A d d e n d u m

Iowa Department of Transportation
Office of Contracts

B.O.	Proposal ID	Proposal Work Type	County	Project Number	Addendum
106	52-3715-649-A	PCC SIDEWALK/TRAIL	JOHNSON	NRT-3715(649)--9G-52	20MAR106.A01

COURT HILL TRAIL - PHASE 3
CITY OF IOWA CITY
PROJECT No. NRT-3715(649)--9G-52

Sheet No.
S.01

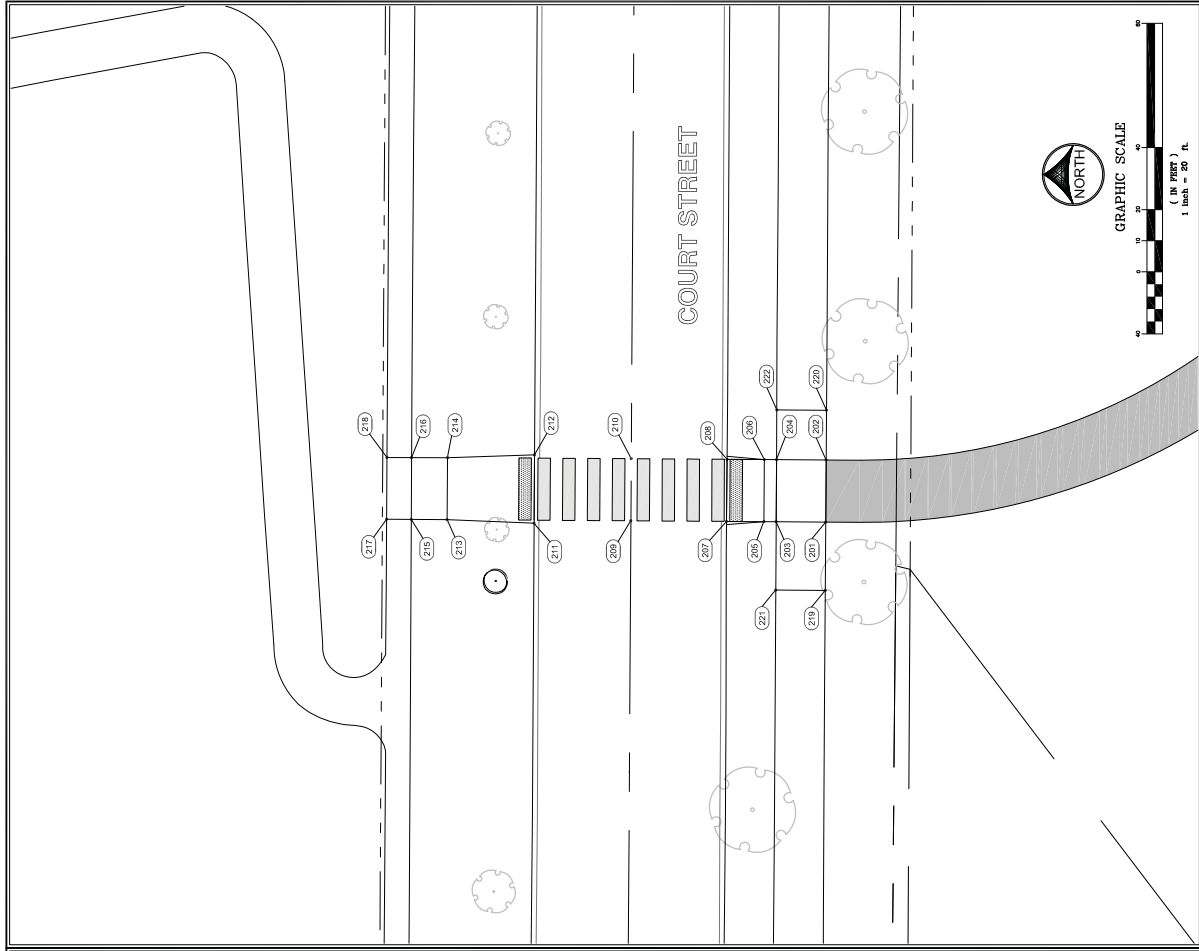
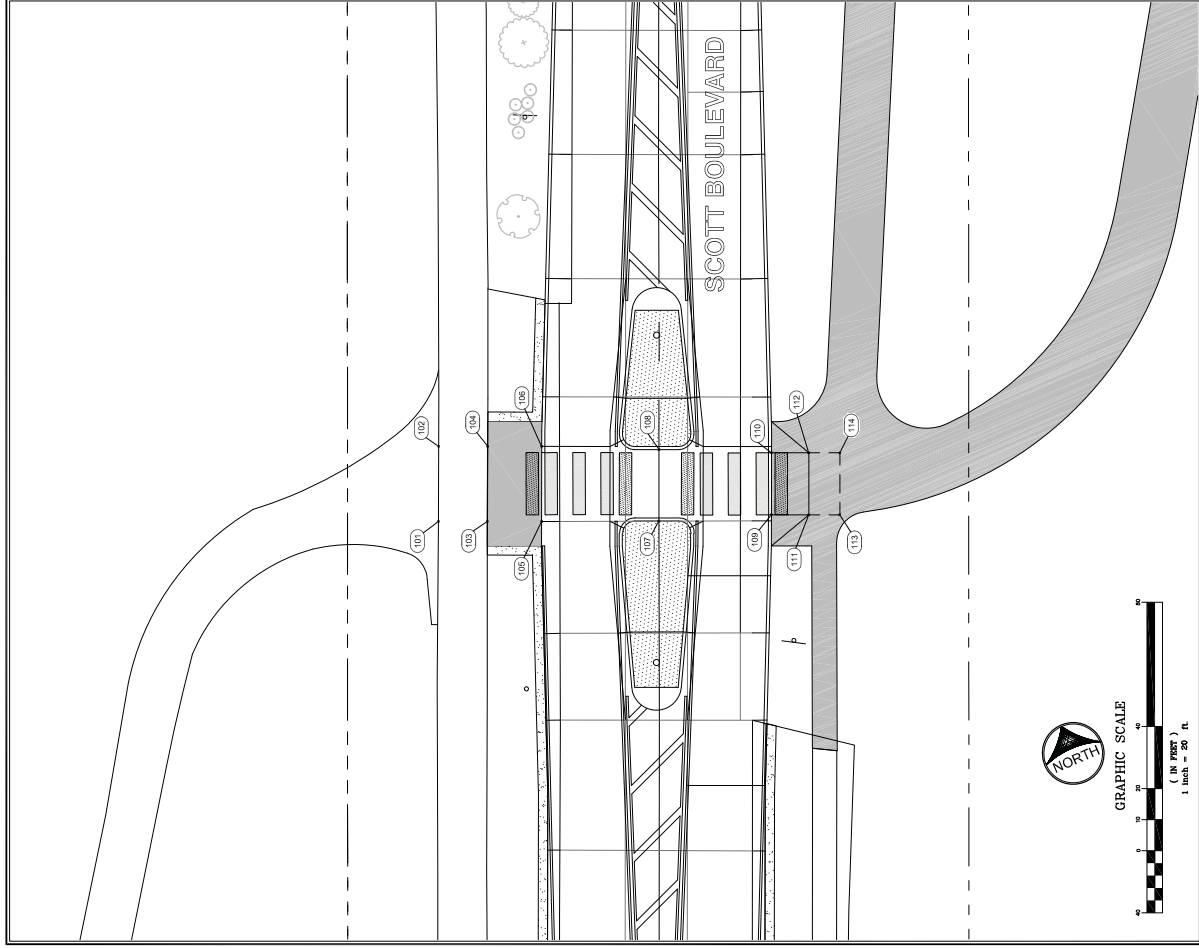
Attached, plan sheets S.01-S.02

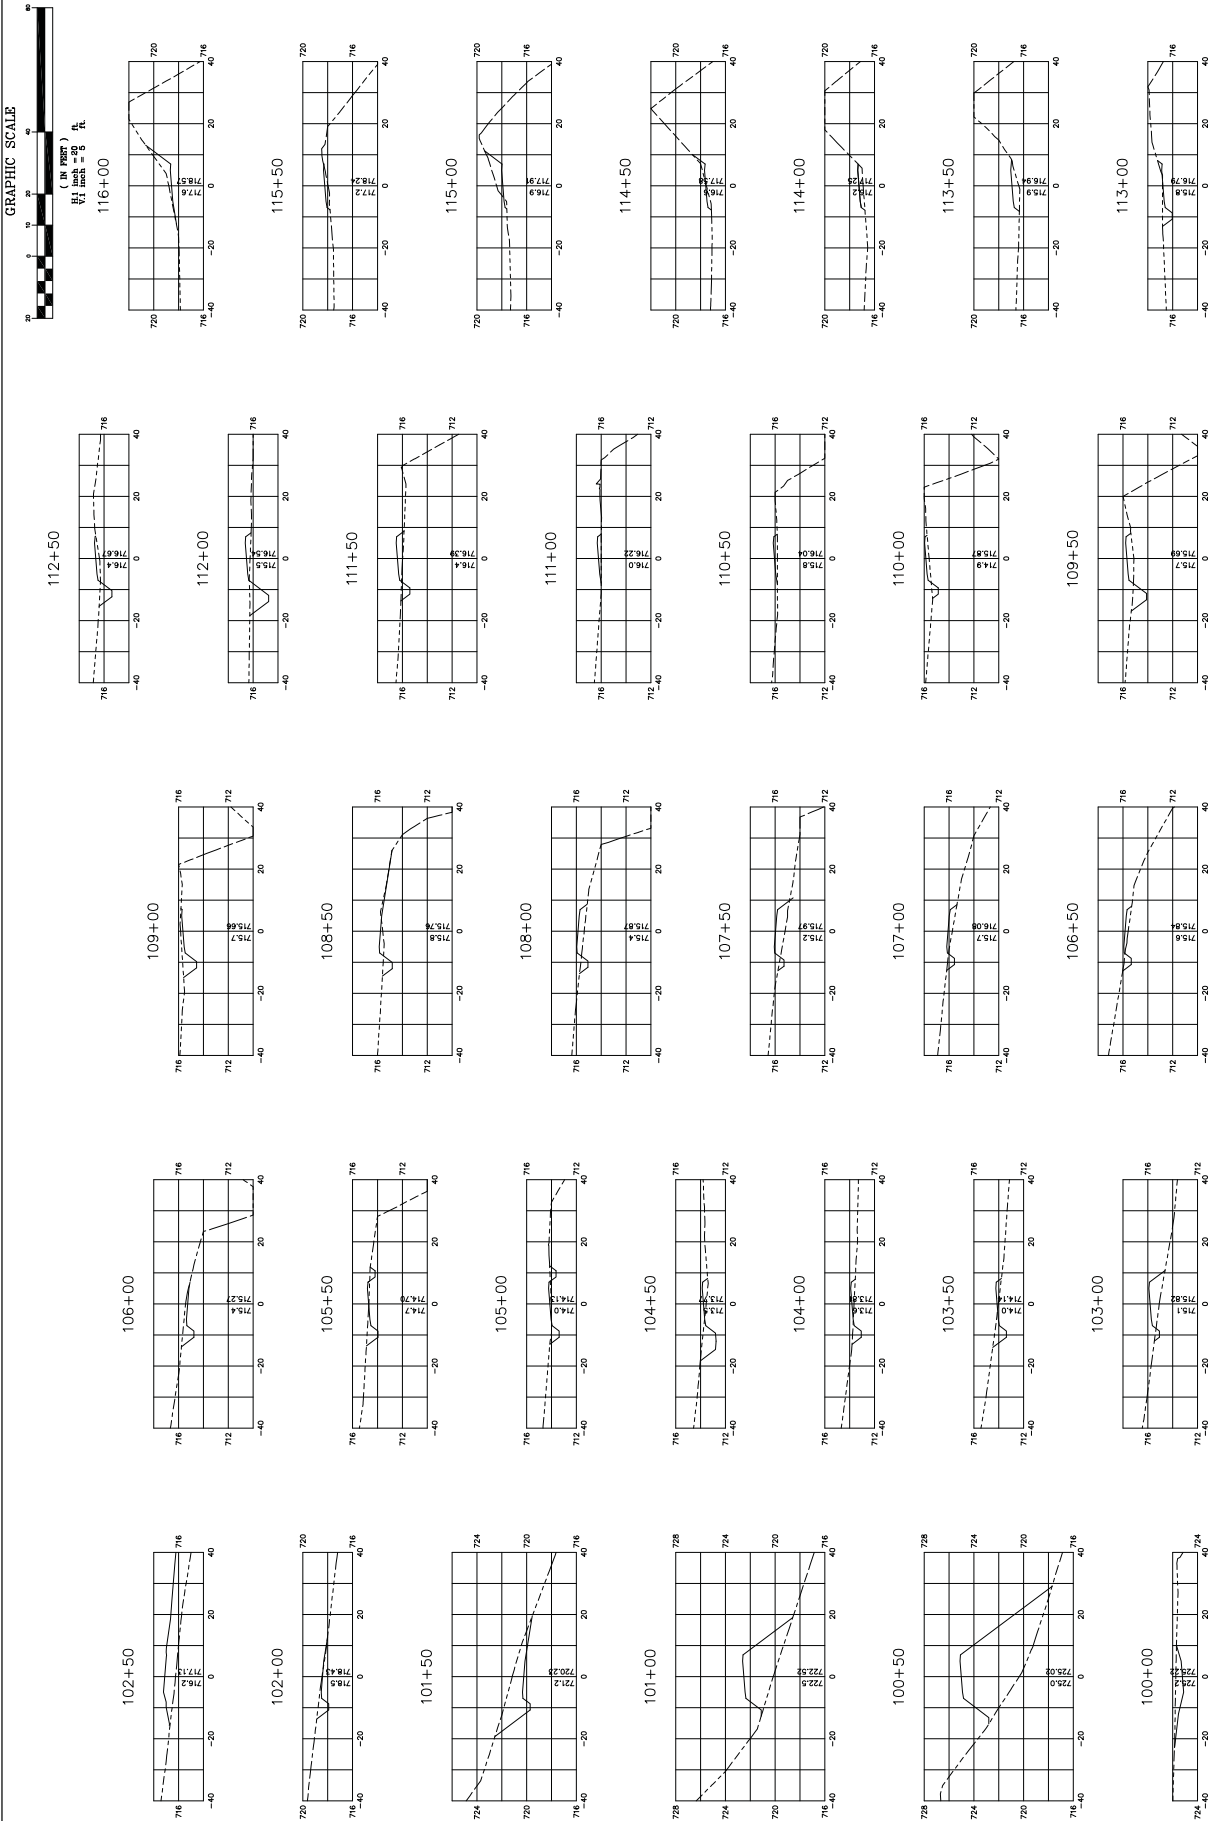
Make the following change to plan sheets X.1-X.4:

Replace plan sheets X.1-X.4 with attached plan sheets X.1-X.4
